Re: GE-Pittsfield/ Housatonic River Site
Newell Street Area II
Proposal for Test Trenching Activities

This letter provides the Environmental Protection Agency's (EPA) conditional approval of the above-referenced *Proposal for Test Trenching Activities* dated October 31, 2005 (Proposal). The Proposal is subject to the terms and conditions specified in the Consent Decree (CD) that was entered in U.S. District Court on October 27, 2000.

**Re: GE-Pittsfield/Housatonic River Site
Newell Street Area II (GECD450)
Proposal for Test Trenching Activities**

FIGURE
1

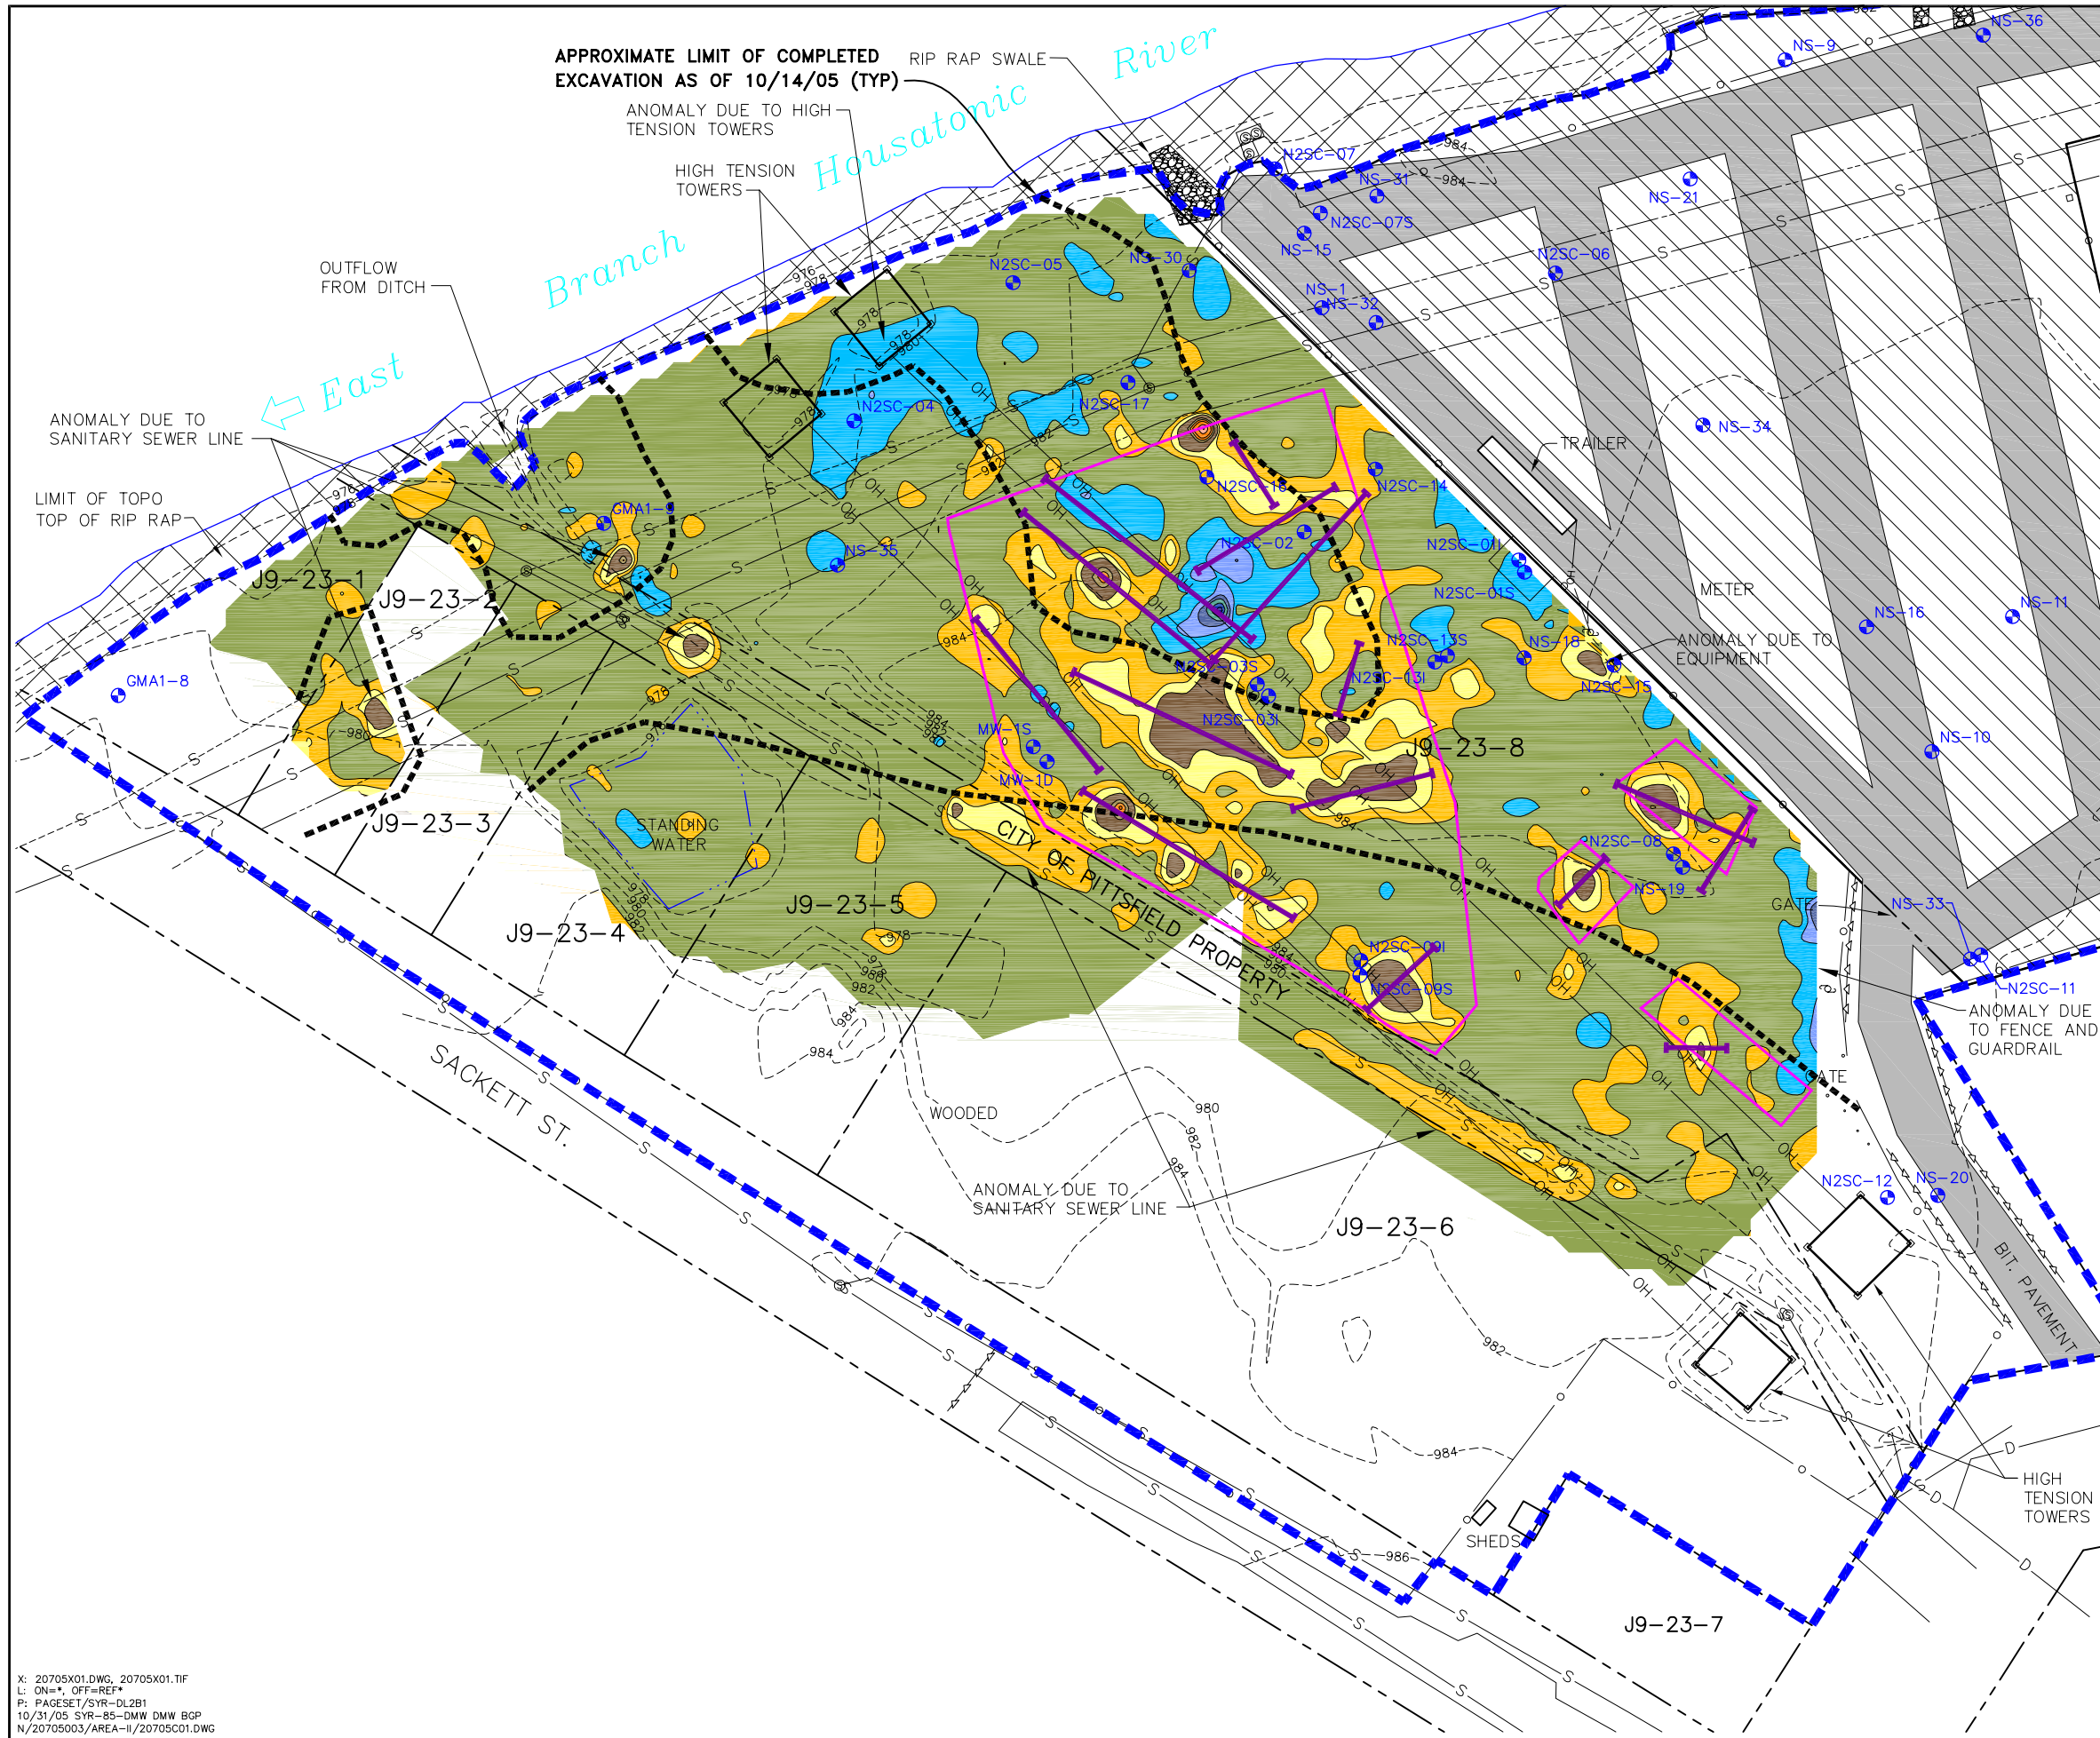
1. GE shall include three additional test trench locations to those shown in figures 1, 2, and 3 of the proposal. The three additional locations include: one test trench running parallel to the river in the vicinity of monitoring well locations N2SC-13S and N2SC-15, a second test trench south of the southwestern corner of the GPR investigation area near N2SC-08, and a third test trench running perpendicular to the river in the vicinity of monitoring well N2SC-17. A revised figure showing the additional locations is attached to this letter.
2. GE shall properly dispose of any soil saturated with non-aqueous phase liquids during the test trenching activities at an appropriate off-site disposal facility.
3. GE shall not backfill any material from the test trenches that will be within three feet of the final grade.
